Demolition of all buildings on site, including a Local Heritage (Townscape) Place and construction of a twenty-one (21) storey hotel building.

51 Pirie Street, Adelaide

020/A131/20

RESPONSE TO COA RFI - 08/07/2020

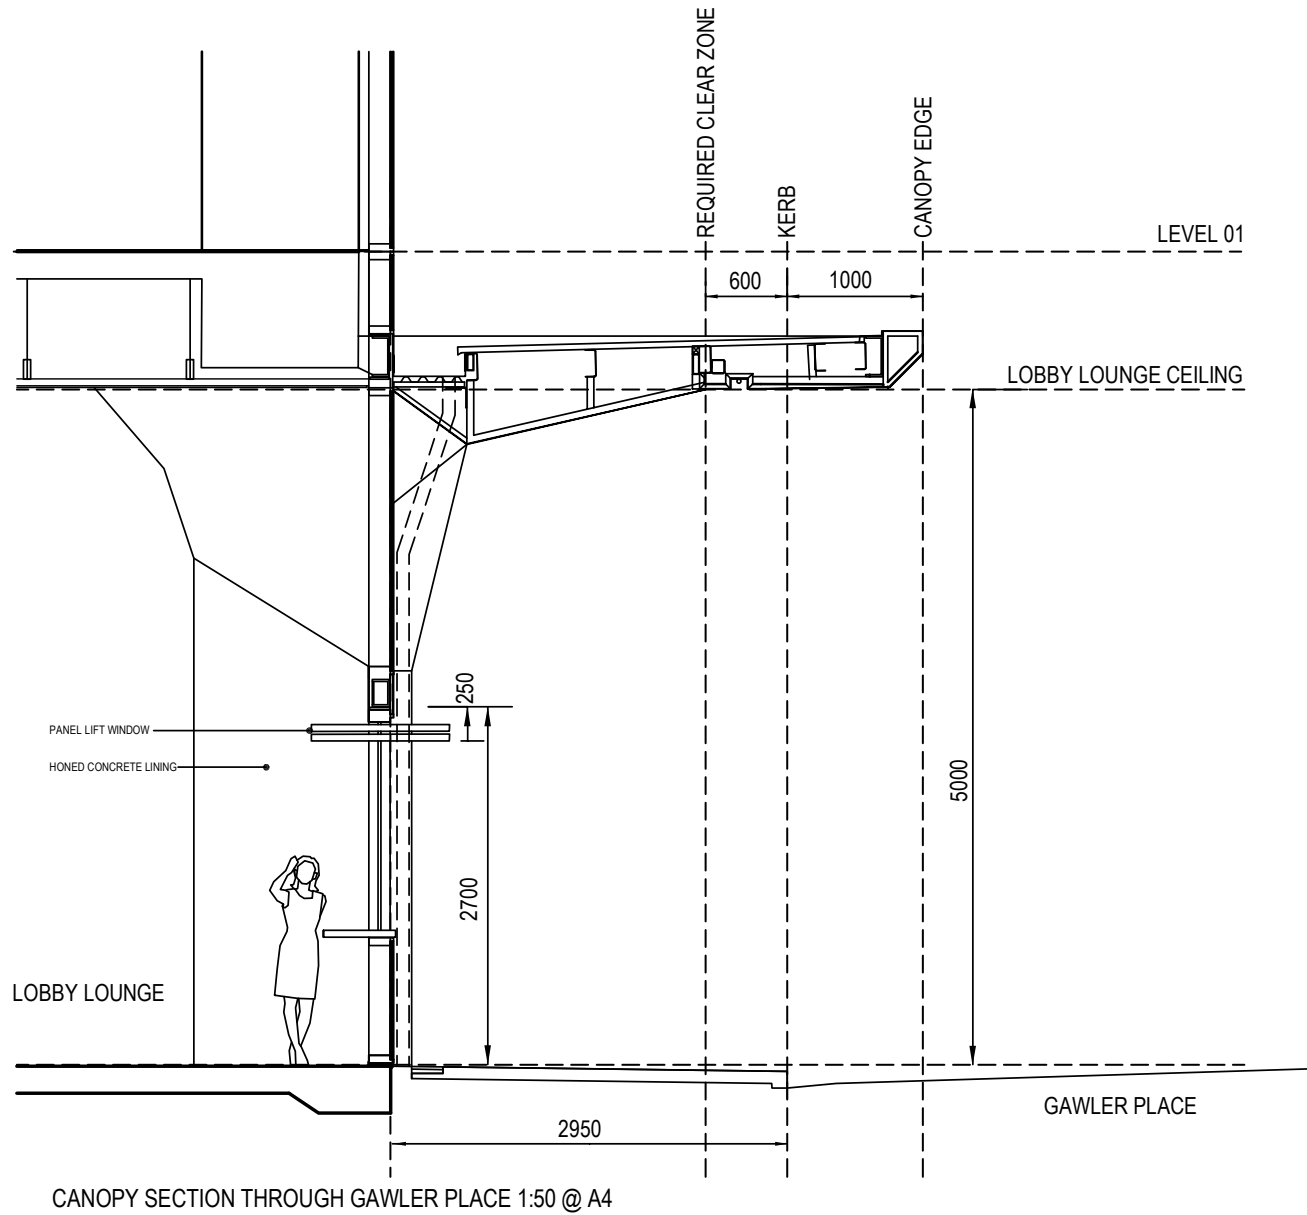
- The canopy edge along Pirie Street will be a minimum of 600 millimetres from the kerb;
- The canopy edge along Gawler Place will be a minimum of 5 metres above the finished floor level for at least 600 mm from the kerb;
- The angular corner at the Pirie Street and Gawler Place intersection has been removed, with the only raised portion of the canopy to be directly above the Pirie Street entrance. Figure 1 below illustrates the revised presentation to the north-eastern corner of the site;
- The Gawler Place access doorway has been amended to ensure that it only opens within the site boundaries; and,
- The elevation plan has been amended to confirm that the vertical bifold windows will be no lower than 2.3 metres above the footpath level at any point.
